## ADDENDUM No. 1

### Rocky Creek Water Reclamation Facility Perimeter Fence Install Project Pre-Bid Meeting – March 24, 2026

DATE: April 1, 2026

# EXHIBIT "A" Proposed Perimeter Fencing Plan

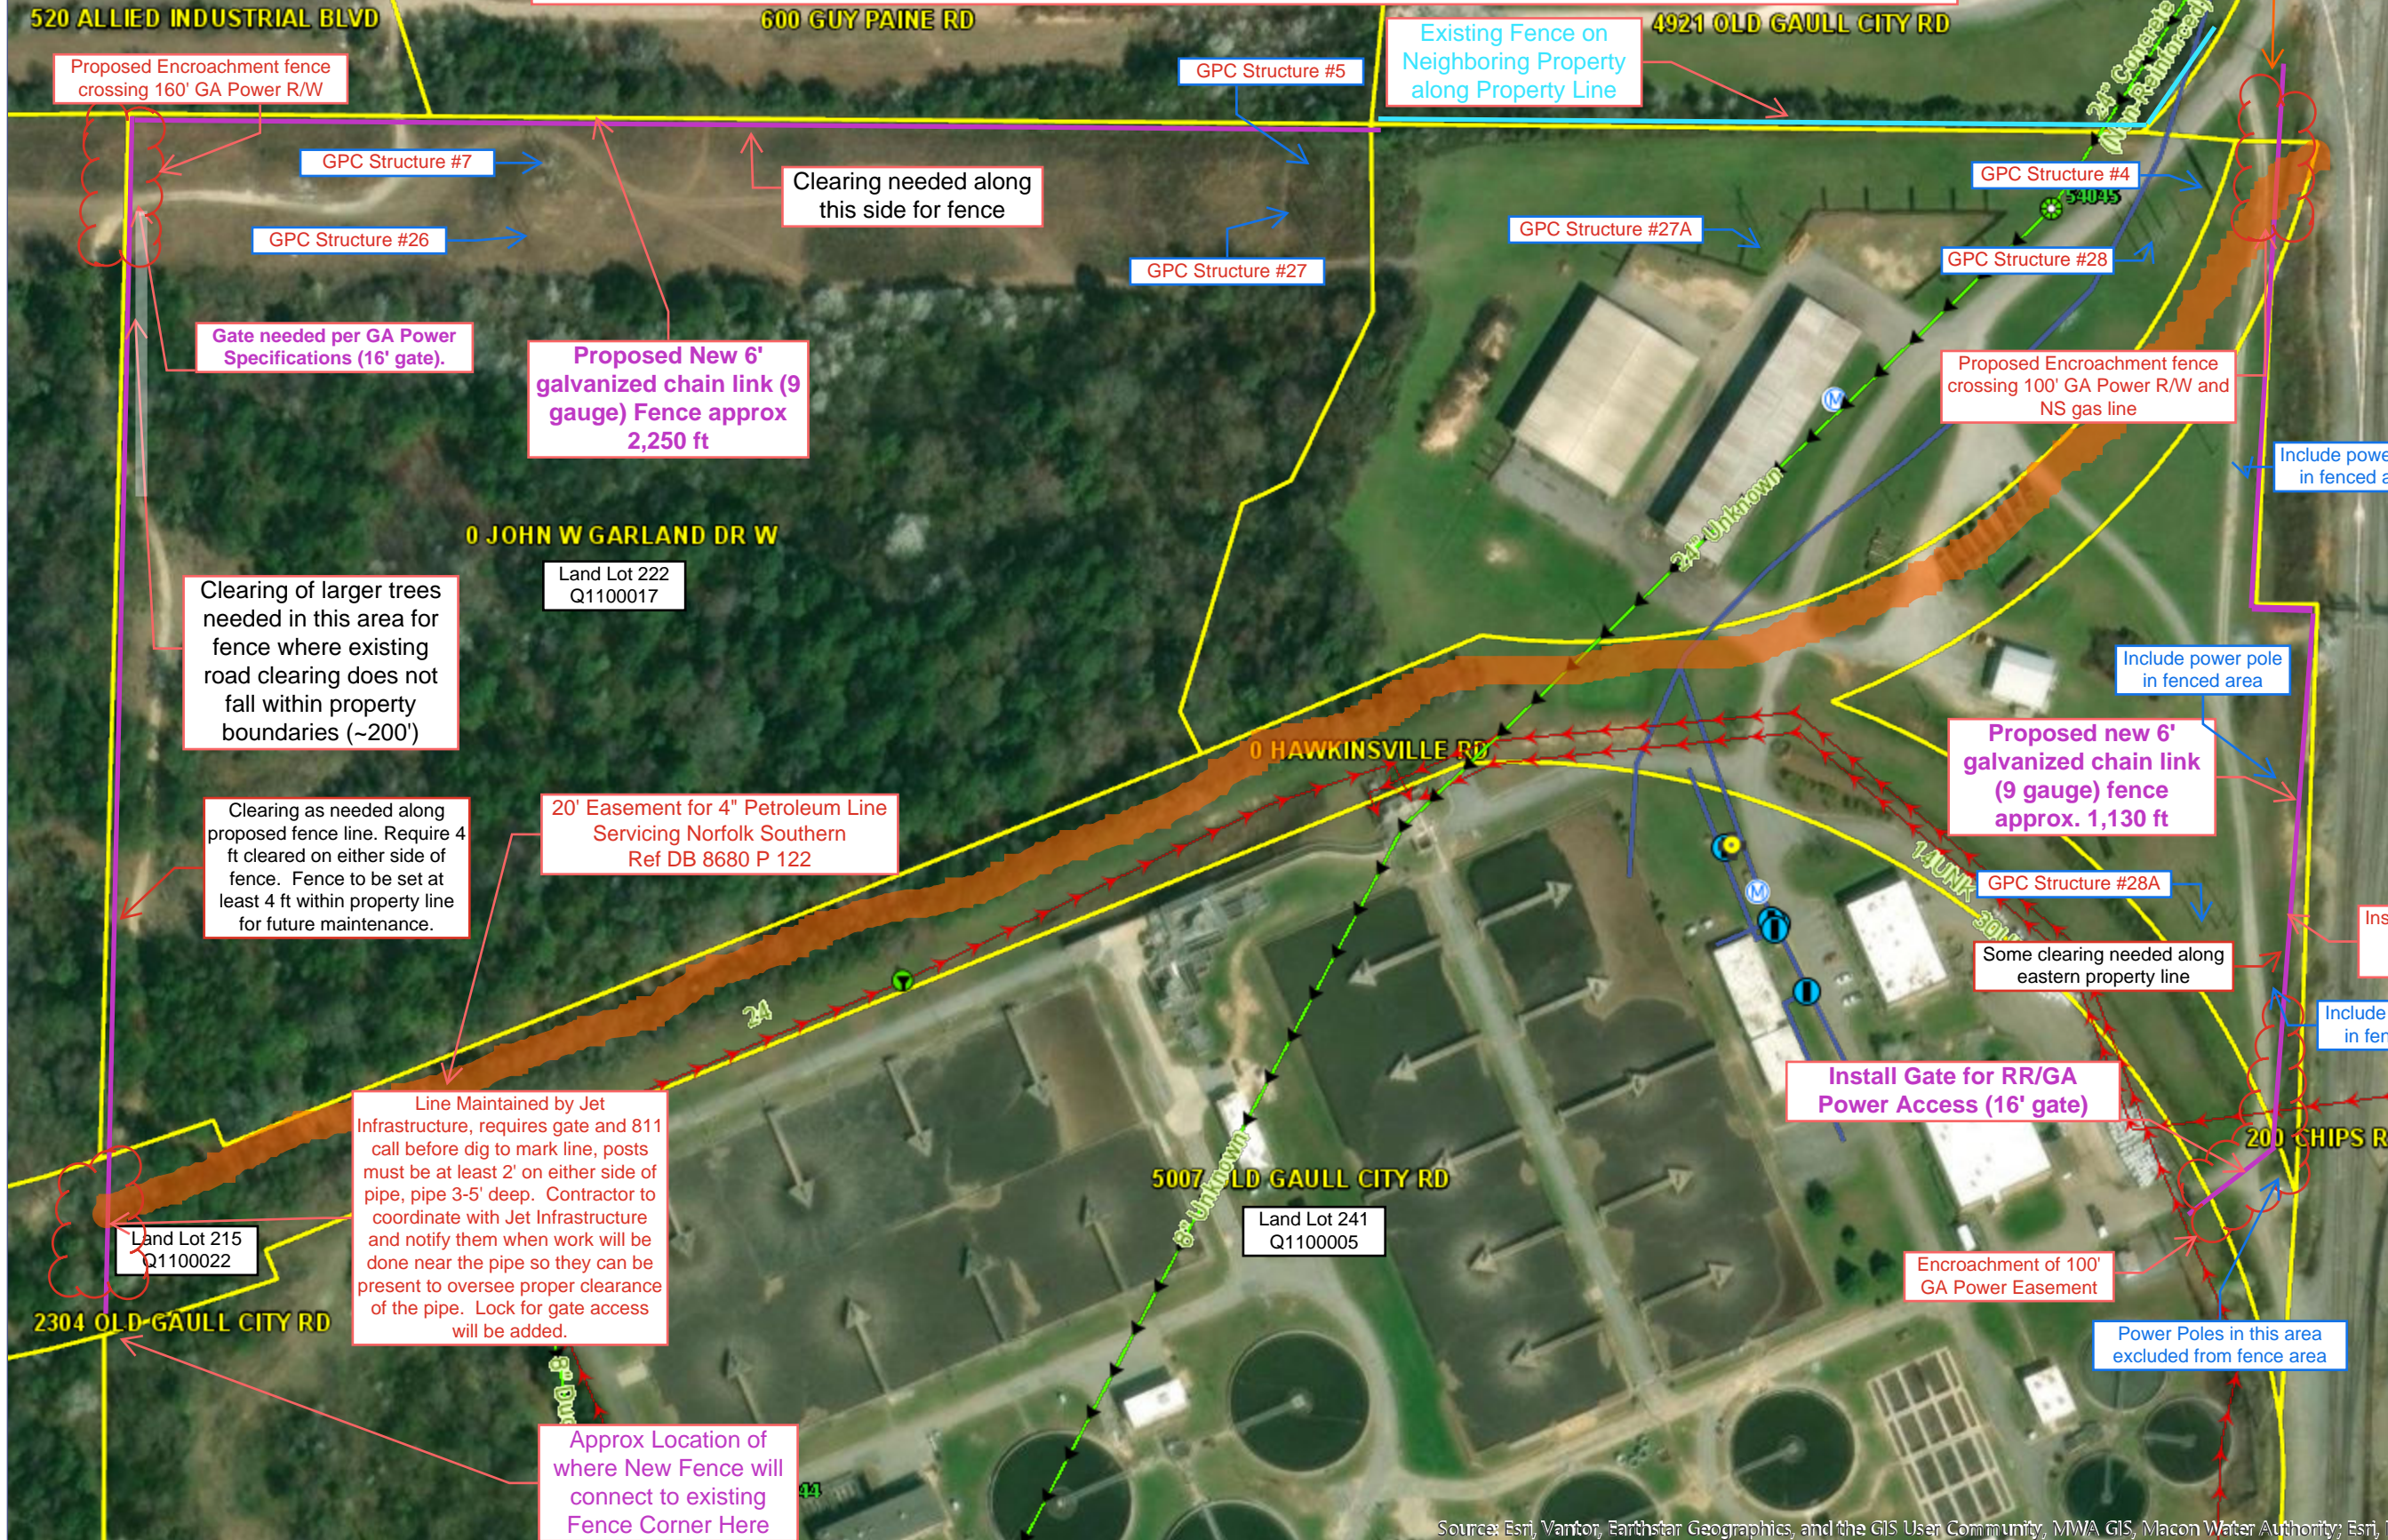
- 2) **QUESTION:** For the ditch that is supposed to be enclosed with a pipe for the fence to cross, how much of that ditch is going to be piped in? Just enough for the fence to cross?  
**RESPONSE:** The ditch shown on the plan to be enclosed with a pipe for the fence crossing has been piped in and fully enclosed. The fence will not cross the other ditches nearby.

3) **QUESTION:** The existing front entrance gate opens past the end of the existing fence (and ditch), where the new fence is supposed to connect (northeast corner of the plan). How will the new fence connect to the existing fence in this location?

8) **QUESTION:** Along the east side of the property, if placement of the fence 4 feet from the property line would have the fence running through ditches, obstructions, or be otherwise problematic, can you adjust its placement to avoid these obstructions and allow enough room from ditches and obstructions?

**10) QUESTION:** Will accommodations need to be made for the railroad right-of way? There appears to be a Railroad signal control house about mid way of the 1130' run that parallels the tracks, it appears that they access it from the plant and the drawing does not show a gate there. Does a gate need to be added, if so what size?

**15) QUESTION:** At the property intersection of the new parcel, 600 Guy Paine Rd, 4921 Old Gaul City Rd. The existing fence is shown on the drawing provided in blue. It appears to be 4-6' offset from the understood location of the new fence. Is the intent to connect to the existing fence come back within the property a few feet and install the run as shown on the drawing provided?

**18) QUESTION:** The 1130' run of fence. The drawings state 4' off the property line. If that location is in the ditch line or on the slope of the ditch is the intent to install the fence on the top/ flat area long the top of the ditch line to allow for proper securement along the bottom?

**RESPONSE:** The end post of the new fence will be set 18 inches from the existing front entrance fence/gate end post to allow clearance for the existing gate. MWA is assessing options to enclose any remaining gaps with a cage around the open gate's remaining overhang, if feasible.

**RESPONSE:** Yes. Due to obstructions, space constraints, and other considerations, especially along the east of the property, setting the fence 4 ft from the property line may not be practical in all areas and placement of the fence will have to be adjusted as necessary under the direction of the Owner and with respect to the distancing requirements for the existing utilities and easements.

**RESPONSE.** MWA is working with Norfolk Southern to confirm their access and distancing needs from structures. An additional gate may be required, and the new fence line location may be adjusted further from the property line in the area concerned once their requirements are confirmed.

**RESPONSE:** The end post for the new fence should be set on MWA's property as close as possible to the end post of the existing fence to minimize any gap. The new fence should run from there further into our property line to allow for the 4' offset from the property line if possible while still complying with Georgia Power's distancing requirements specified in the encroachment agreement (Exhibit "B" of the contract documents).

**RESPONSE:** Yes, in areas where setting the fence 4 ft. off of the property line would cause it to run into a ditch, on the slope of a ditch, or into another obstruction or other undesirable placement, the fence line should be adjusted accordingly under the direction of the owner and with respect to the distancing requirements for the existing utilities and easements.
